UNITED STATES PATENT AND TRADEMARK OFFICE

APPLICATION NO.	FILING DATE	FIRST NAMED INVENTOR	ATTORNEY DOCKET NO.	CONFIRMATION NO.
10/767,459	01/30/2004	Robert S. Anderson	P-6464-US2	3936
49443	7590	01/13/2006		
PEARL COHEN ZEDEK, LLP 10 ROCKEFELLER PLAZA SUITE 1001 NEW YORK, NY 10020			EXAMINER JOHNSON III, HENRY M	
			ART UNIT	PAPER NUMBER
			3739

Office Action Summary	Application No. 10/767,459	Applicant(s) ANDERSON ET AL.	
	Examiner Henry M. Johnson, III	Art Unit 3739

DETAILED ACTION

Fig. 2B

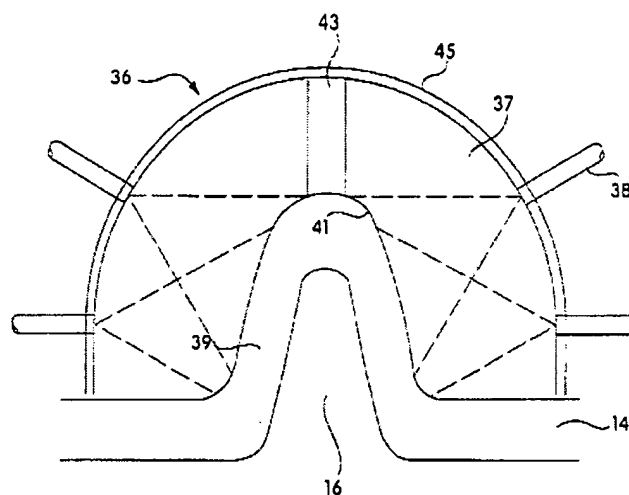
Claims 1-3, 6-15, 16-18, 20-25, 27, 29, 30, 46, 47, 49 53-55 are rejected under 35

U.S.C. 102(e) as being anticipated by U.S. Patent 6,605,080 to Altshuler et al. Altshuler et al.

teaches methods for treating tissue with electromagnetic radiation wherein tissue (Fig. 2B, # 39) is

positioned near radiating elements (Fig. 2B,

38) and irradiated via the elements.

Tissue is drawn into the handpiece via a

suction port (Fig. 2B, # 43), the tissue being
